Project # PR-2022-007219,  
SI-2022-01478, VA-2022-00235  
Major Amendment to allow for a  
new multi-family development  
and a Variance - EPC to the  
required Landscape Buffer. EPC  
Approval September 15, 2022

<b>MONTGOMERY/ WYOMING APARTMENTS</b> <b>SITE PLAN</b>	DRAWN BY RMG DATE 02/15/2023 2022030_SITE PLAN 02.15.23
	 5571 MIDWAY PARK PLACE NE ALBUQUERQUE, NM 87109 (505) 858-3100 www.tierrowestllc.com	SHEET # <b>SP-1</b> JOB # 2022030

**RE: Titan - WFH  
Conceptual Grading & Drainage Plan  
Engineer's Stamp Date: 04/18/23  
Los Pastores Master Drainage Plan Amendment Report  
Engineer's Stamp Date: 04/01/23  
Hydrology File: F19D013D**

**Project # PR-2022-007219**  
SI-2022-01478– Site Plan – Major Amendment  
VA-2022-00235-Variance- EPC

04/18/2023	<b>ENGINEER'S SEAL</b> <b>RENOVA AT WYOMING</b>	DRAWN BY RMG
	<b>CONCEPTUAL GRADING PLAN</b>	DATE 04/18/2023
TIERRA WEST, LLC 5571 MIDWAY PARK PLACE NE ALBUQUERQUE, NM 87109 (505) 858-3100 www.tierrowestllc.com		2022030 GRADING PLAN SHEET # <b>GR-1</b> JOB # 2022030

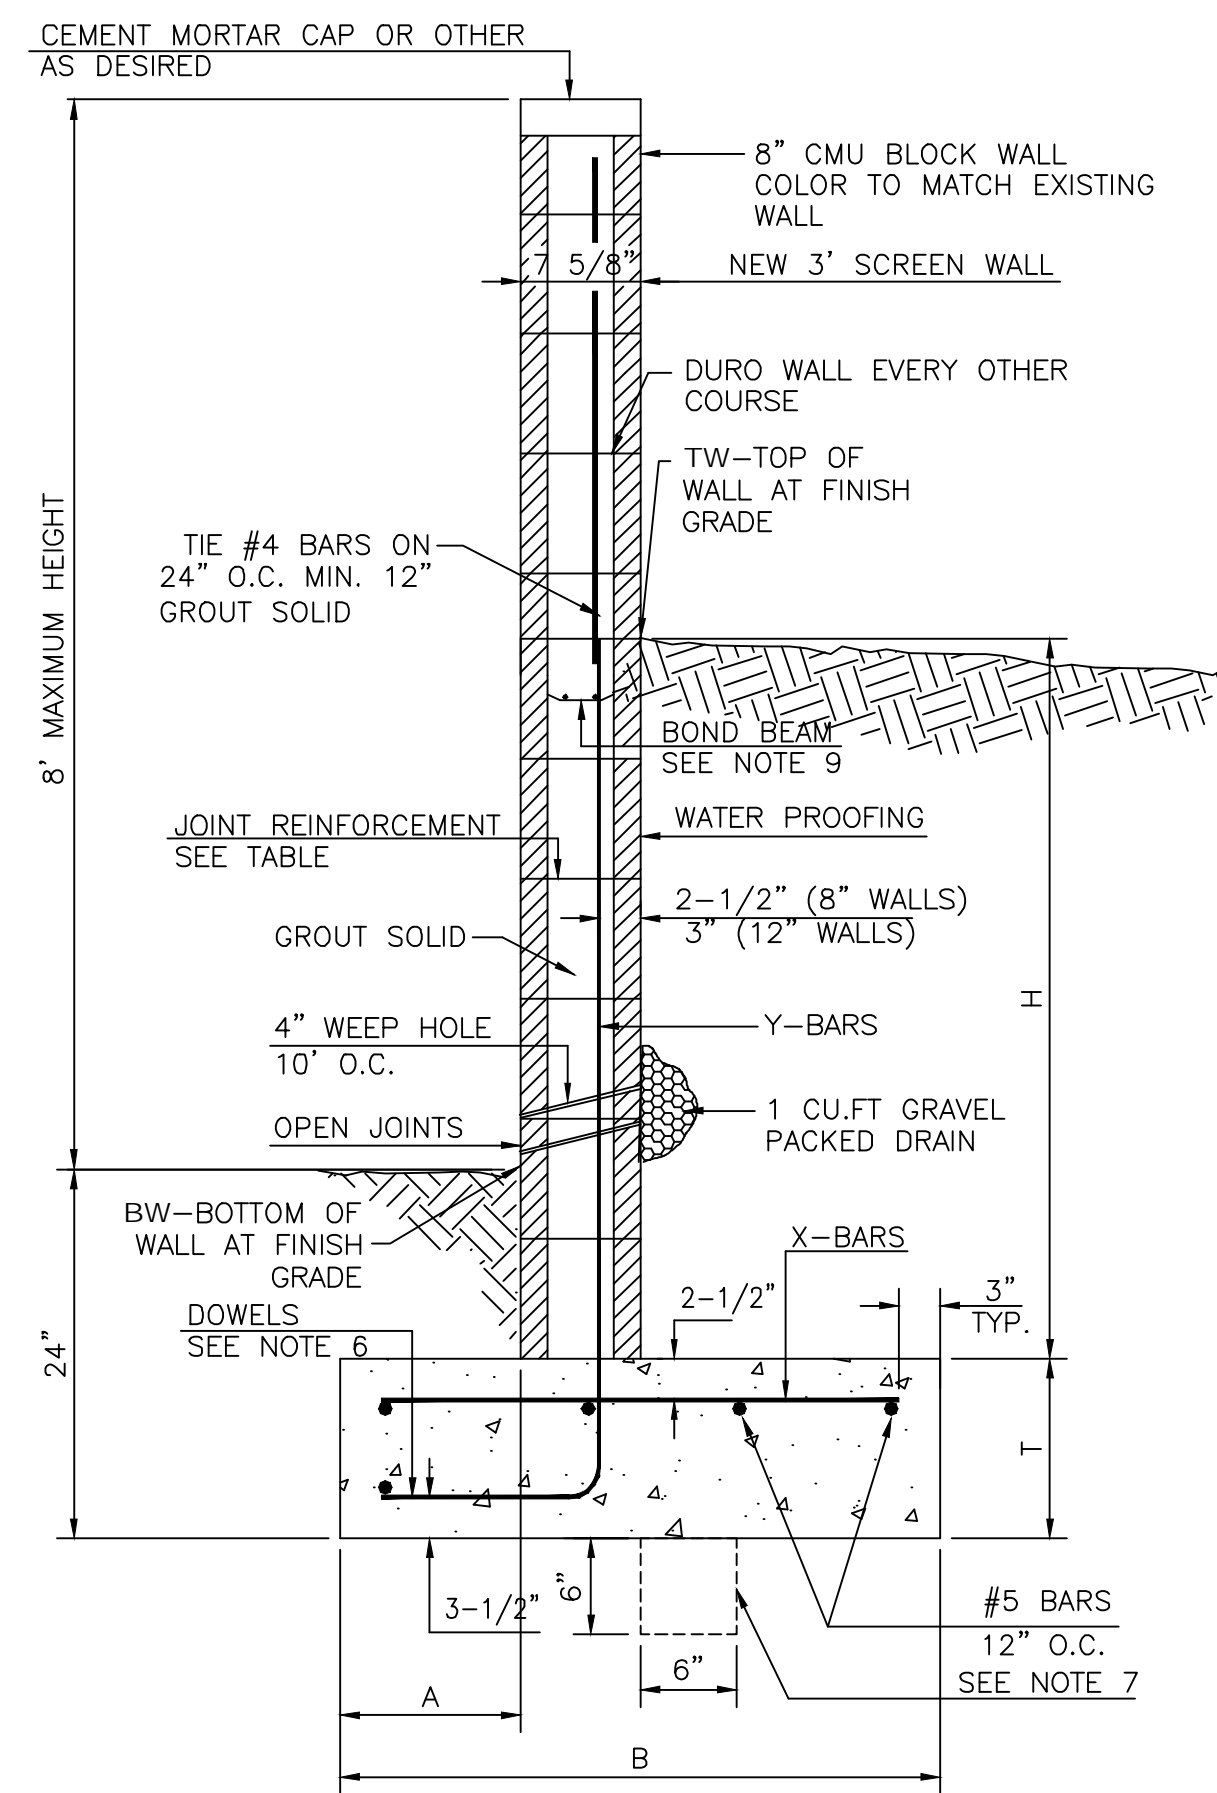
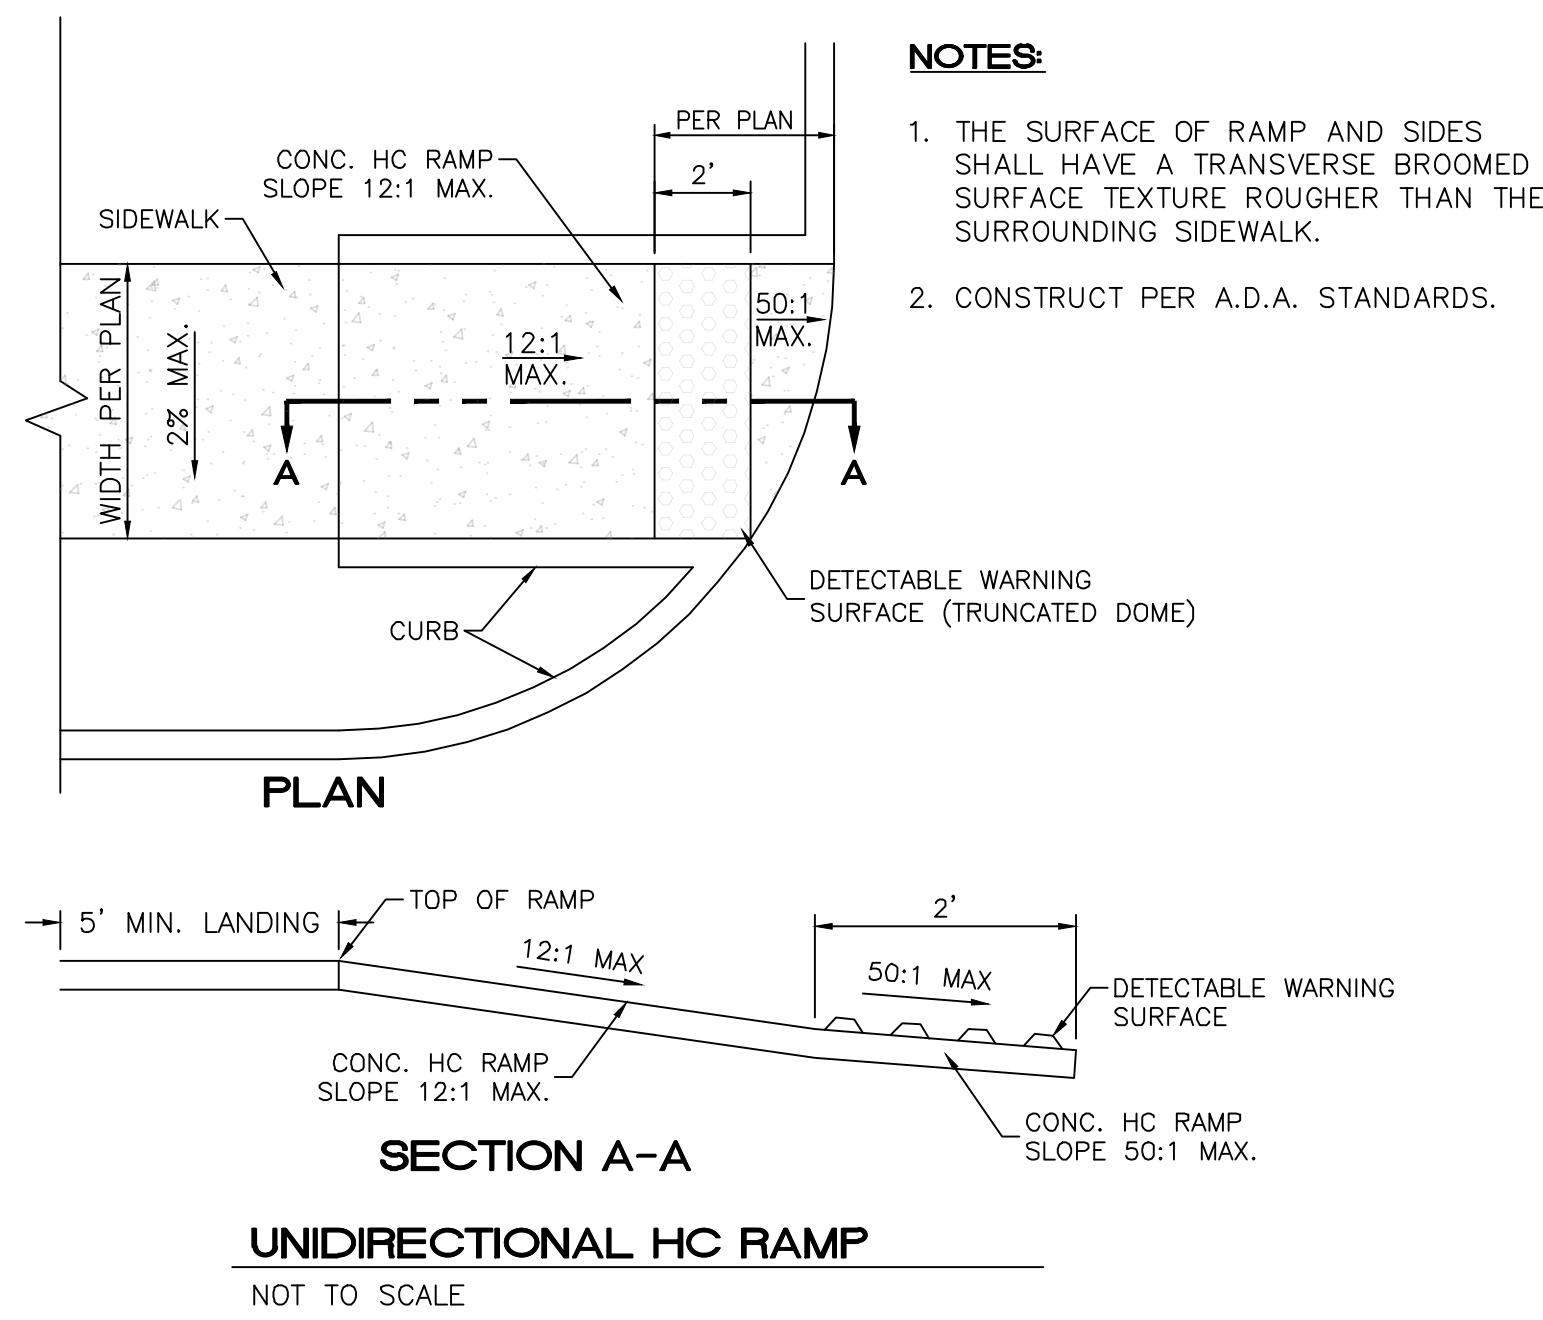
1. Please submit a more detailed Grading & Drainage Plan to Hydrology for review and approval. This digital (.pdf) is emailed to [PLNDRS@cabq.gov](mailto:PLNDRS@cabq.gov) along with the Drainage Transportation Information Sheet.

**16 LIGHT POLE**  
SCALE = 3/4" = 1'-0"

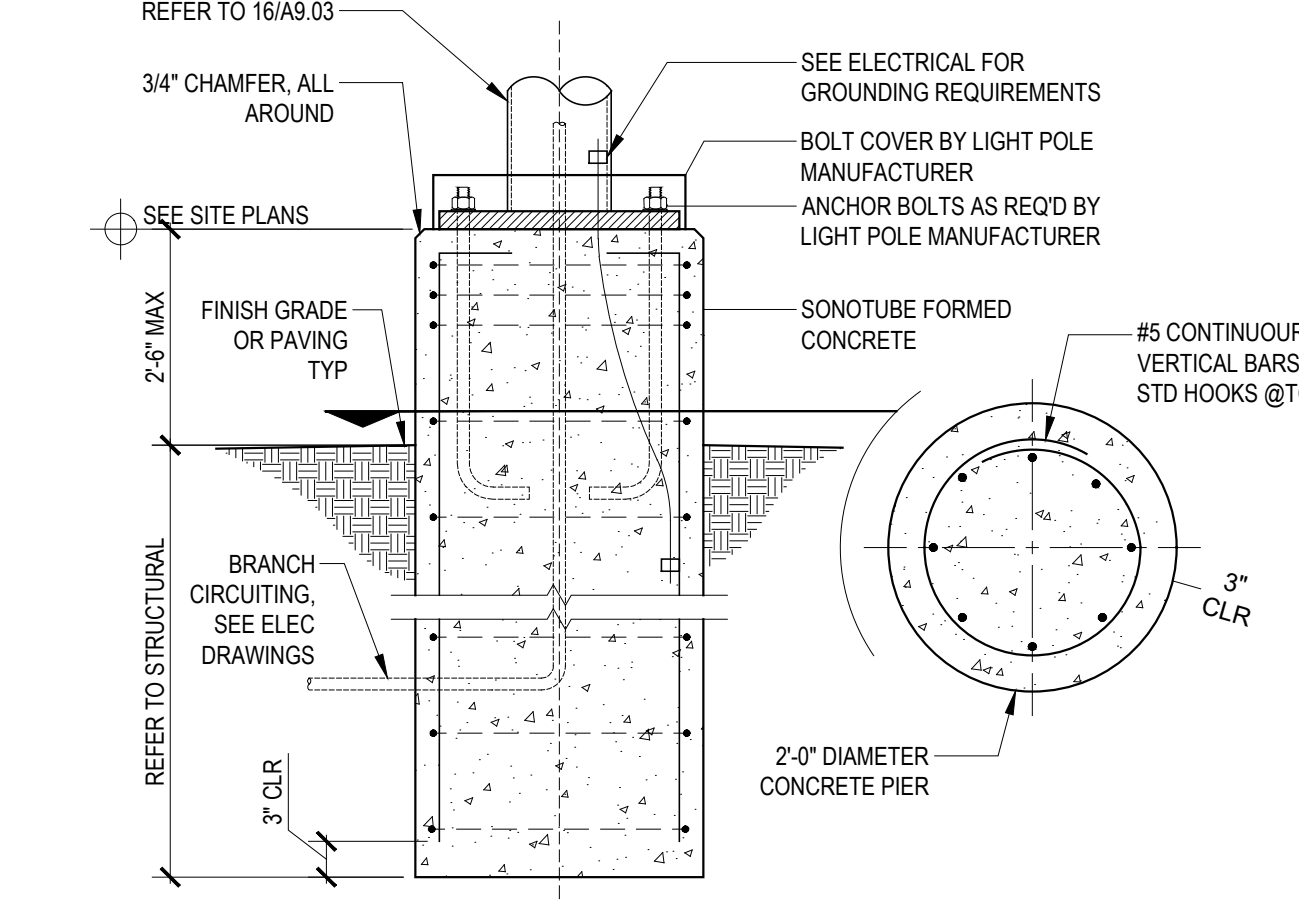
9. Lighting:
- A. Show locations of light poles on the site plan.
  - B. Provide light pole detail indicating height, color, and finish.
  - C. Lighting shall comply with design standards.

*Light pole detail has been added to Sheet A9.03, Detail #16.*
